Work Order ID 160073

Item ID: 646.3315 Accept ***N900040100*** Setup Start ***NS1***
Revision ID: Stop ***NS2***
Item Name: Blade
Start Date: 4/25/2017 Start Qty: 12.00 ***12*** Cust Item ID:
Required Date: 5/10/2017 Req'd Qty: 12.00 ***12*** Customer:
Reference: (P.A.)SCHEDULED/S

ENGINEERING CHANGE NOTICE NO.

DWG TITLE: UPPER CUTTER ASSY

SHEET 5 IS:

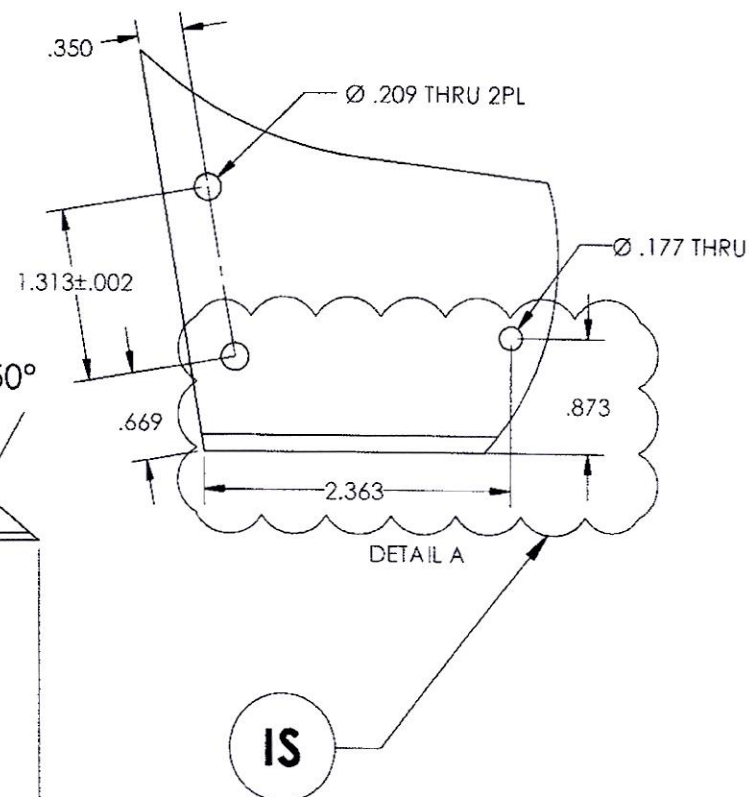
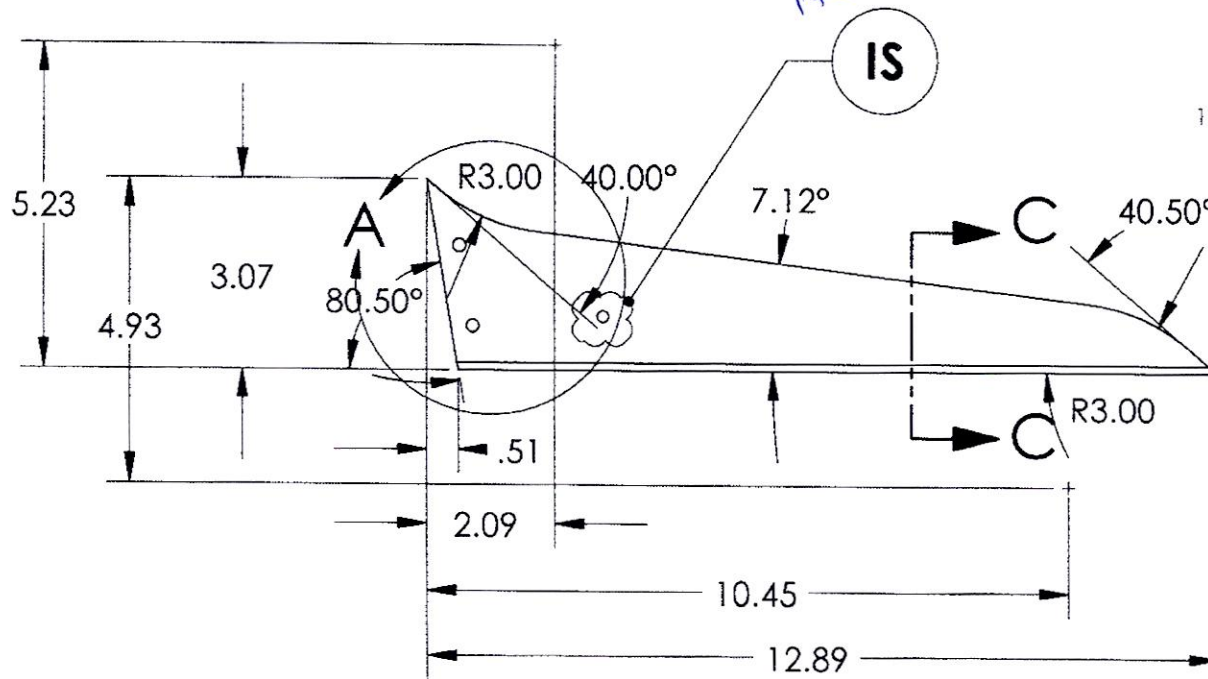
REASON: ADDED HOLE DIMENSION TO 646.3313.

SHEET 4, ZONE B8 IS:

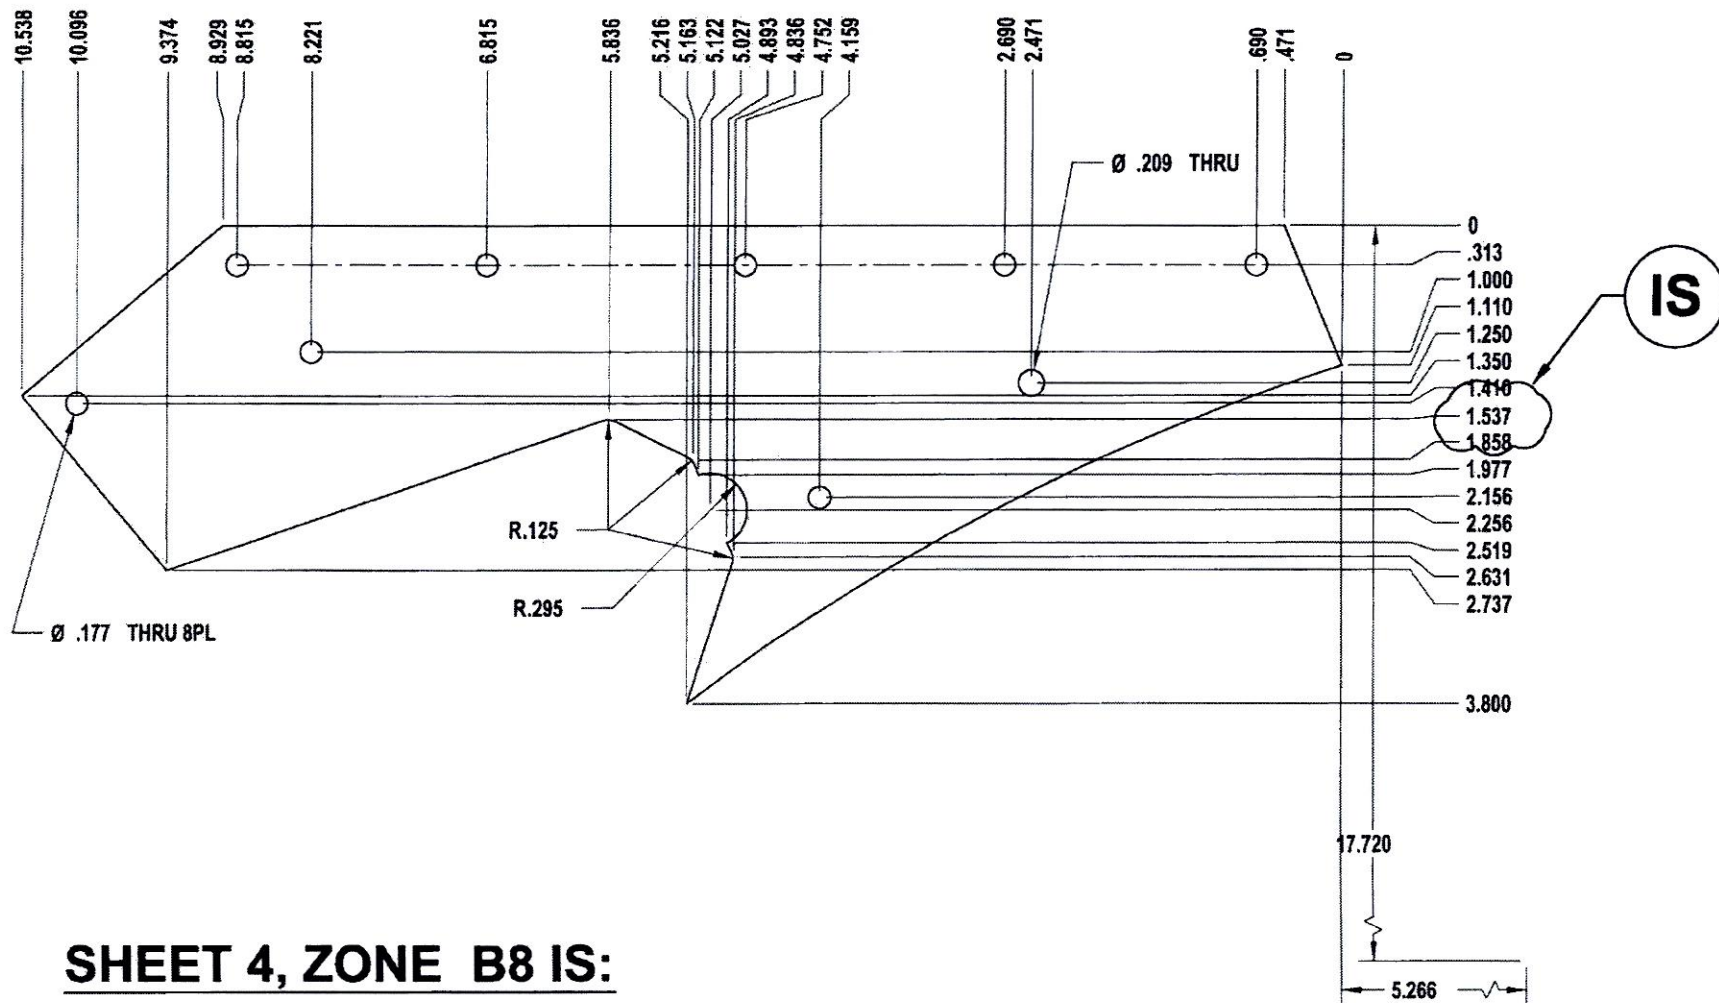
APICAL INDUSTRIES, INC.	ENGINEERING CHANGE NOTICE NO. 03724				SHEET 1 OF 1	
	DWG NO. 646.3300	REV: N/C	PREPARED BY B. PETERS	DATE: 12/05/12	EFFECT ON DWG ☐ INC. ☒ UNINC.	
	DWG TITLE: UPPER CUTTER ASSY					
	APPROVED BY: ENGR <i>[Signature]</i>	MFG <i>[Signature]</i>	QC <i>[Signature]</i>	EFF: NEXT ORDER		
TRANSACTION CODES (TC): A-ADD C-CREATE R-REVISE D-DELETE	REASON: REVISED ORDINATE DIMENSION.				ECR: D-12-025

SHEET 1, VIEW 646.3301, IS:

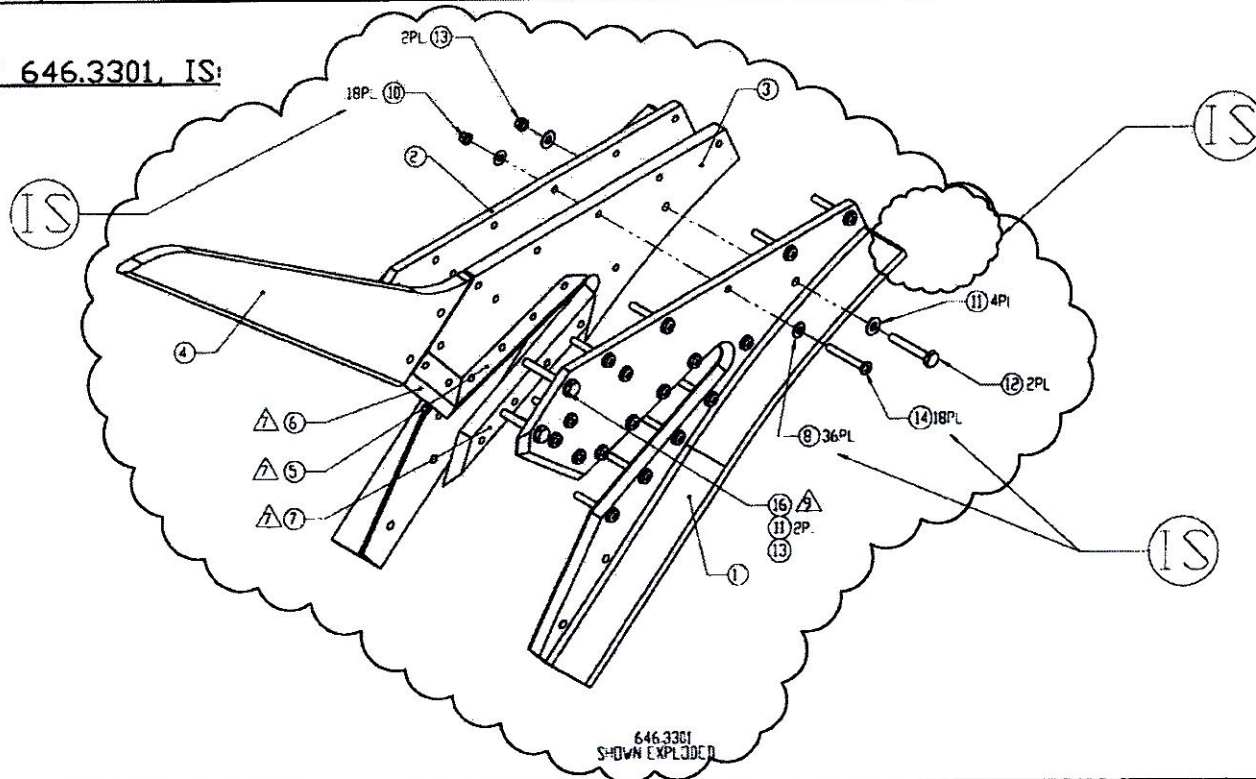
APICAL INDUSTRIES, INC.	ENGINEERING CHANGE NOTICE NO. 02196		SHEET 1 OF 2	
	DWG NO. 646.3300	REV: N/C	PREPARED BY S. HUFF	DATE: 01/05/09
	EFFECT ON DWG ☐ INC. ☒ UNINC.			
DWG TITLE: UPPER CUTTER ASSY				
APPROVED BY: ENGR <i>[Signature]</i>	MFG <i>[Signature]</i>	QC <i>[Signature]</i>	EFF: NEXT ORDER	
TRANSACTION CODES (TC): A-ADD C-CREATE R-REVISE D-DELETE	REASON: REMOVED RIVETS IN FAVOR OF ADDITIONAL SCREWS

14	R	601.2765	18	SCREW	MS27039-0819
10	R	601.1541	18	LOCKNUT	MS21042L08
9	D	601.2766	3	RIVET	MS20470AD5-18
8	R	601.2764	36	WASHER	NAS1149FN832P
			.3301		
F/N	TC	PART NUMBER	QTY	DESCRIPTION	MATERIAL/SPECIFICATION
DOCUMENTS EFFECTED: ☐ MDL ☒ INSTALL INSTRUC ☒ ICA ☐ FMS ☒ BOM					CHANGE CATEGORY: ☐ MAJOR ☒ MINOR
					DER REVIEW REQUIRED: ☐ YES ☒ NO
